Access Compliance Report
Public Rights-of-Way
(Curb Ramps)

Intersection ID: 45774	**Main Street:** CARVER_FALLS_RD	**Cross Street:** HART_RD	**Location:** S
ADA ID: 819283E5210E	**Ramp Type:** Perp	**Initial Pass/Fail:** Fail **Overall Compliance:** No	**Severity Score:** 8.75

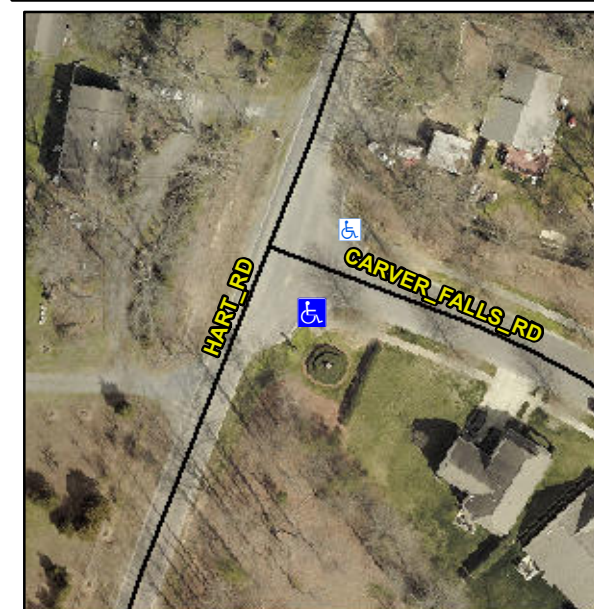
R304.5.1

Compliance	**Description**	**Data**	**Compliance**	**Description**	**Data**
N/A	Ramp Length (in)	73.5	Yes	Ramp Slope (%)	6.1
No	Ramp Width (in)	47.0	Yes	Ramp XSlope (%)	0.2
N/A	Flare Type LT	N/A	N/A	Flare Type RT	N/A
N/A	Flare Slope LT (%)	N/A	N/A	Flare Slope RT (%)	N/A
N/A	Flare Traversable LT?	N/A	N/A	Flare Traversable RT?	N/A
N/A	Landing Length (in)	N/A	N/A	DWS Provided?	N/A
N/A	Landing Width (in)	N/A	N/A	DWS Contrast?	N/A
N/A	Landing Slope (%)	N/A	N/A	DWS Length (in)	N/A
N/A	Landing X Slope (%)	N/A	N/A	DWS Full Width?	N/A
N/A	Landing Curb? (Y/N)	N/A	N/A	DWS Offset (in)	N/A
N/A	Shared Landing?	N/A			
N/A	Gutter Ponding?	N/A	N/A	Gutter Slope (%)	N/A
N/A	Gutter Lip Ht (in)	N/A	N/A	Gutter X Slope (%)	N/A
N/A	Painted X Walk1?	No	N/A	Painted X Walk2?	N/A
	X Walk 1 Direction	To NE		X Walk 2 Direction	N/A
N/A	X Walk 1 Width (in)	N/A	N/A	X Walk 2 Width (in)	N/A
	X Walk 1 Slope (%)	4.6		X Walk 2 Slope (%)	N/A
	X Walk 1 X Slope (%)	2.0		X Walk 2 X Slope (%)	N/A

Remove & Replace Entire Ramp.
